CITY PLAN COMMISSION STAFF REPORT

The Collection at Staley Hills

CD-CPC-2025-00076, Development Plan

CD-CPC-2025-00077, Rezoning

PRELIMINARY PLAT

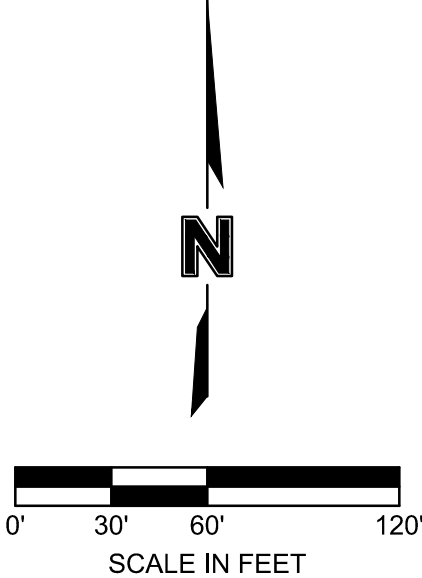
8. That the developer obtain a variance to the setback required by 88-323-03-A or revise the development plan to meet the R-2.5 district setback prior to issuance of building permit.
